# **3 Quarry Road Dural, NSW**

**BCA Compliance Report**

Project: 3 Quarry Road, Dural, NSW

This document constitutes a Building Code of Australia 2016 (BCA) assessment report for the proposed retirement village and residential aged care development located at 3 Quarry Road, Dural, NSW.

Figure C-1: Extended Travel Distance Example, Class 3 Areas

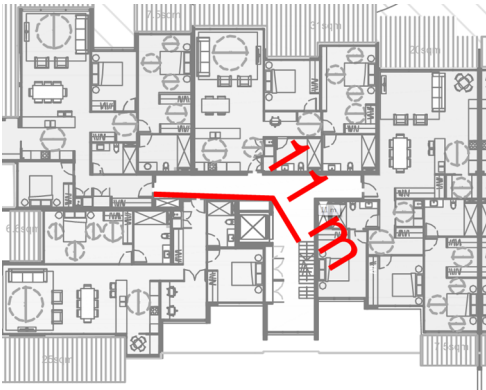
5.	D1.4(a)(i)(A)	<p>In Class 3 areas, the entrance doorway of a sole-occupancy unit must be no greater than 6 m from a single exit or from a point of choice of alternative exits, other than on ground level where this distance may be 20 m. This distance is exceeded on above ground levels, being up to approximately 12 m.</p> <p><i>Holmes Fire can provide a Performance Solution to address the extended travel distances.</i></p>	DP4 and EP2.2

Figure C-2: Ground Level travel distance non-compliance (example)

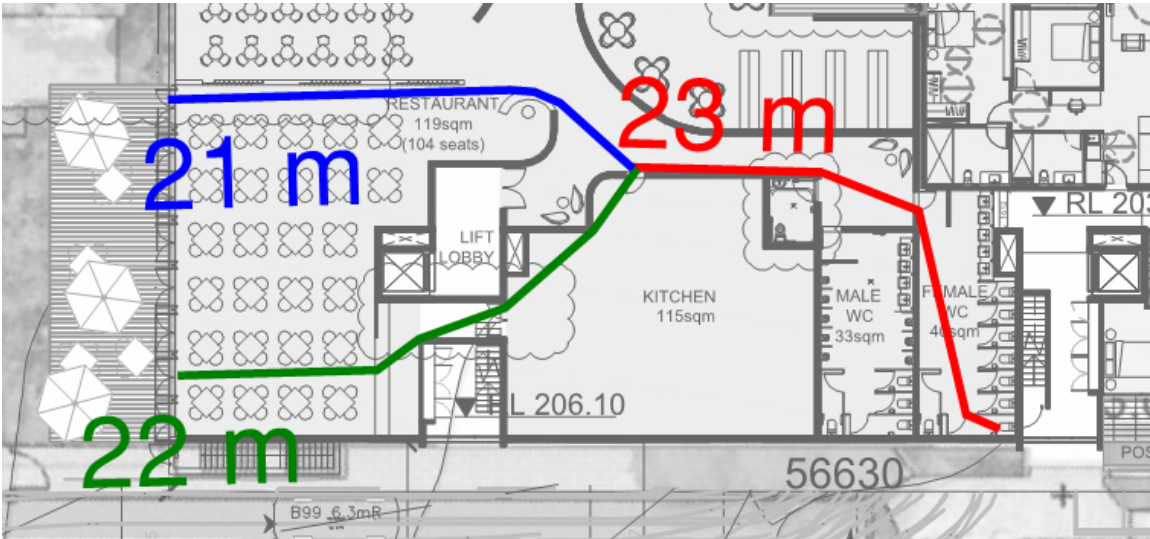
Issue	BCA Clause	Description	Performance Requirement
6.	D1.4(c)(i)	<p>In Class 6, 7a, 9b, and 9c areas, every point on a floor must be located no more than 20 m from a single exit or to a point of choice of exits, to which the maximum travel to the nearest exit shall be no greater than 40 m.</p> <ul style="list-style-type: none"> <li>Travel distances within the basement carpark exceed 20 m to appoint of choice and 40 m to an exit (see Appendix C).</li> </ul> <p><i>Holmes Fire can provide a Performance Solution to address the extended travel distances.</i></p> <ul style="list-style-type: none"> <li>Travel distance within the Ground Floor facility areas exceed 20 m to a point of choice and 40 m to an exit (see Appendix C).</li> </ul> <p><i>Holmes Fire can provide a Performance Solution to address the extended travel distances within the Ground Floor Facility areas.</i></p> <ul style="list-style-type: none"> <li>Travel distance in the RAC building, on storeys above ground, exceed 20 m to a point of choice, being up to approximately 33 m (see Appendix C).</li> </ul> <p><i>Holmes Fire can provide a Performance Solution to address the extended travel distances within the RAC building. However, it is considered to be more cost effective to provide secondary doors swinging in the direction of egress in the smoke walls, as indicated in Appendix C.</i></p> <p><i>The travel distance to a point of choice, when addressed through a Performance Solution, is recommended to not exceed 30 m, and the travel distance to the nearest exit to not exceed 60 m.</i></p>	DP4 and EP2.2

Figure C-4: Basement 2 Travel Distances (example)

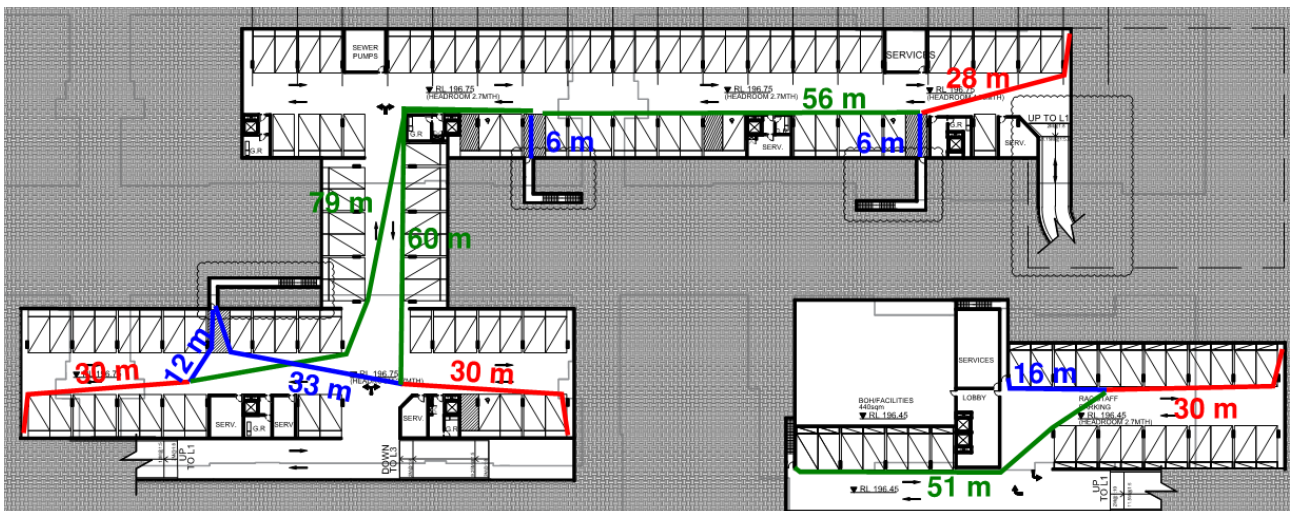
7.	D1.5(c)(ii)	<p>In a Class 7a building the maximum travel distance between alternative exits must be no greater than 60 m. Additional stairs are required throughout the basement carpark, see Appendix C.</p> <p><i>Holmes Fire can provide a Performance Solution to permit an increased distance between alternative exits within the basement levels, thereby reducing the number of stairways and increasing usable floor space.</i></p>	DP4 and EP2.2

In a Class 7a building the maximum travel distance between alternative exits must be no greater than 60 m.	The distance between the exits in the basement exceed the BCA DTS limits. Refer to Appendix C for example markups. <i>A Performance Solution is possible to provide an increased distance between alternative exits within the basement levels of approximately up to 80 m, thereby reducing the amount of excess stairways and increasing usable floor space.</i>	<input type="checkbox"/>	<input checked="" type="checkbox"/>	<input type="checkbox"/>	<input checked="" type="checkbox"/>	<input checked="" type="checkbox"/>
D1.6 NSW Dimensions of exits and paths of travel to exits	The unobstructed height and width of required exits or paths of travel to exits must be no less than 2 m and 1 m respectively. The aggregate egress width per storey is based on the number of persons accommodated, as calculated by D1.13.	Note that the aggregate egress width from the facilities areas are to be refined as the design progresses. Compliance is achievable.	<input type="checkbox"/>	<input checked="" type="checkbox"/>	<input checked="" type="checkbox"/>	<input type="checkbox"/>	<input type="checkbox"/>
